**SECTION 009111
ADDENDUM NUMBER 1**

1.01 DATE: 11 MARCH 2026

1.02 PROJECT: MUSICAL ARTS CENTER ROOF REPLACEMENT PHASE 2

5.01 DRAWING A222 - ROOF DETAILS

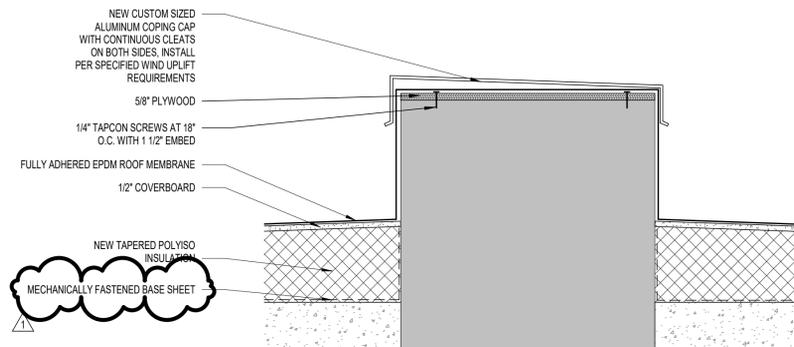
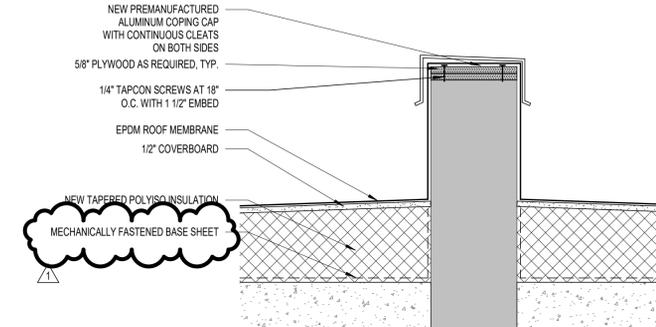
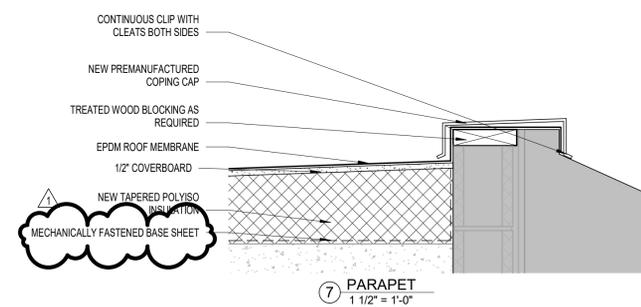
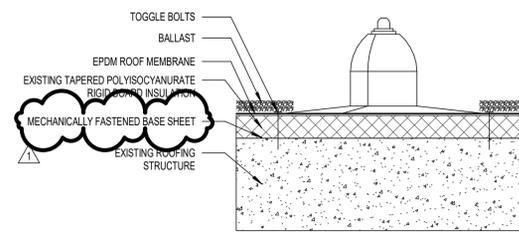
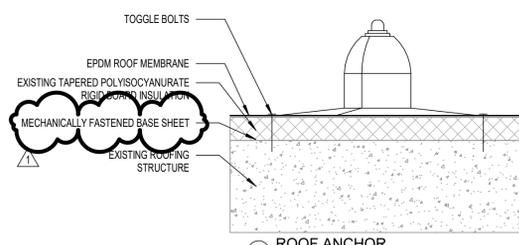
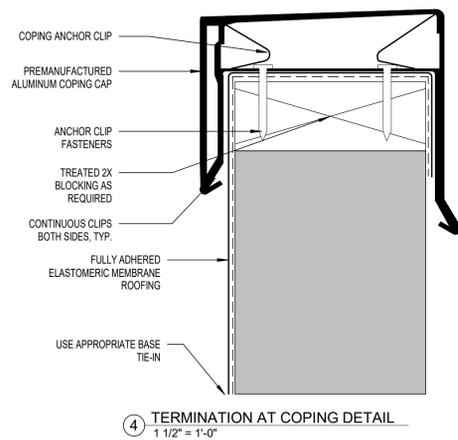
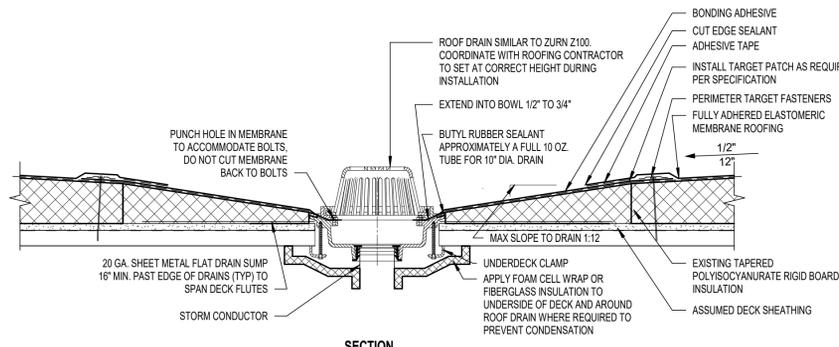
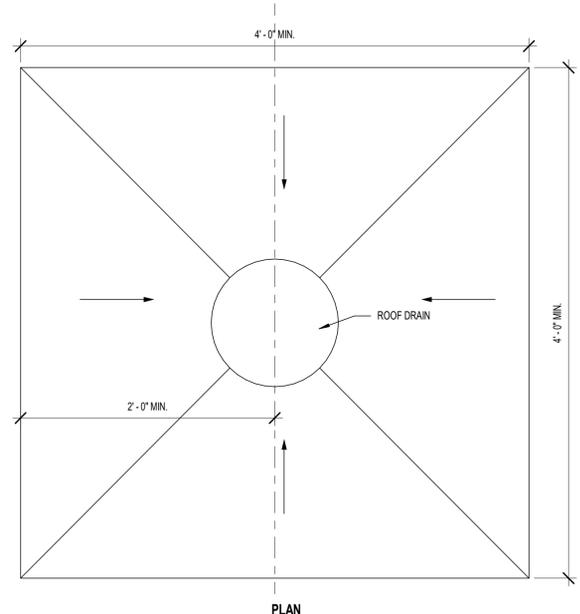
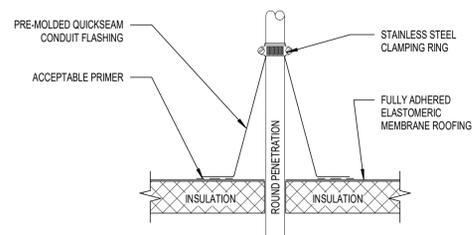
- A. Revise Details 01, 02, 04, 05, 06, 07, 08, and 09 to delete vapor barrier and add mechancially fastened base sheet.
